MANAGEMENT OF CHANGE

By Bill Lape, SCS Engineers

It happens to everyone. We miss a detail that mucks up the works. In this edition of Epic Fails, we will look at a failure to manage a change fully.

Figure 1: Fan Submittal

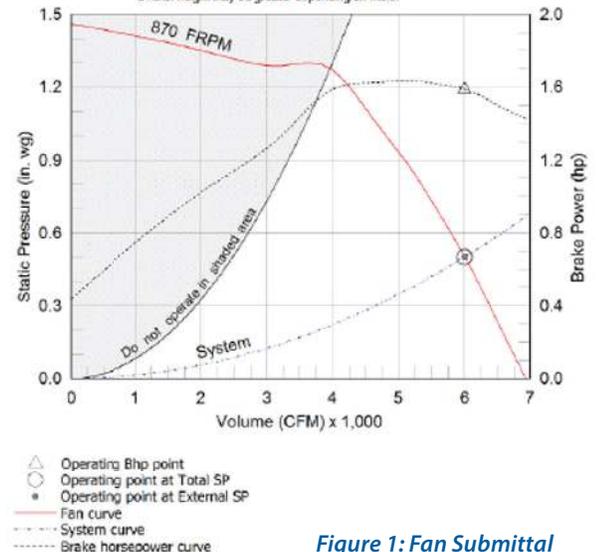
If we review the submittal sheet for the fan in Figure 1, we see that this model is capable of 6000 CFM, more than enough for the required emergency ventilation rate, but not enough to limit the temperature rise in the room properly. Since this was the only fan to be installed in the machinery room, it does not meet the requirements of IAR2.

Another requirement in IAR2 is that the fan motor must be of the totally enclosed type if it is in the airstream or inside the machinery room. This requirement is identical between IAR2-2014 and IAR2-2021. Since the motor on this fan is on top of the fan unit outside of the air stream, the ODP type motor called out in the submittal is acceptable.

This re-wording of the requirement was done to clarify what is meant by non-sparking construction. Note that the submittal sheet does not state if this fan is "non-sparking" construction. However, a look at the manufacturer catalog shows that this fan and housing is of aluminum construction, making it non-sparking.

Figure 2: Fan Catalog

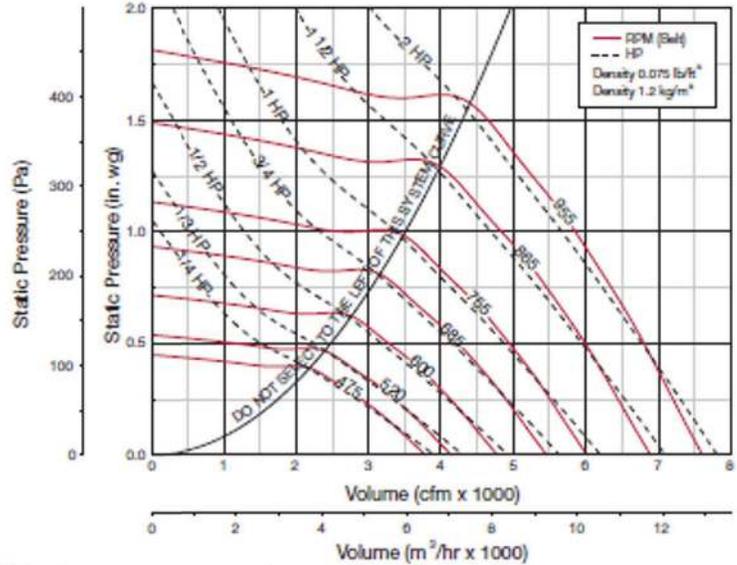
Now, where might we find the discharge velocity for this fan? It is not clearly indicated on the submittal sheet. In fact, the only place to find the discharge velocity for the fan outside of placing a call to the manufacturer's representative is a formula buried in the catalog. As figure 2 shows, the average discharge velocity for the model fan that was selected is calculated by using the following formula:

$$fpm = \frac{CFM}{3.76}$$
$$fpm = \frac{6000}{3.76} = 1595.7 fpm$$

As you can see, the fan is well under the minimum 2,500 fpm as required by IAR2.
